febiEXAKT

Diverter Valve

febi no. 39245

Repl. No. 06H 145 710 D

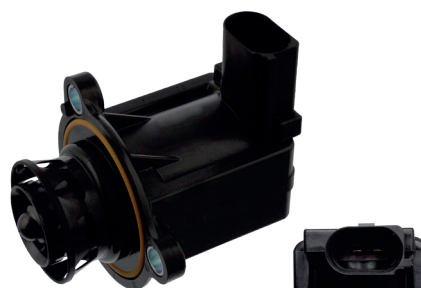
The old version of the valve has a rubber diaphragm which can be the reason why the unit fails (see Fig. 2). The full charging pressure is no longer built up as air is pumped in a circuit even with the throttle flap open.

If the brakes are suddenly applied at high speed and the throttle flap closes, the valve's slow switching times also prevent the dynamic pressure downstream of the compressor from reducing which consequently creates the “turbo lag” effect. This not only results in unnecessary slowing down of the turbocharger but also places an enormous load on the closed throttle flap and the turbocharger's turbine end.

febi bilstein recommends replacing the diverter valve with the most up-to-date version (febi 39245). As a piston version (see Fig. 3), the piston ensures that the valve functions perfectly.
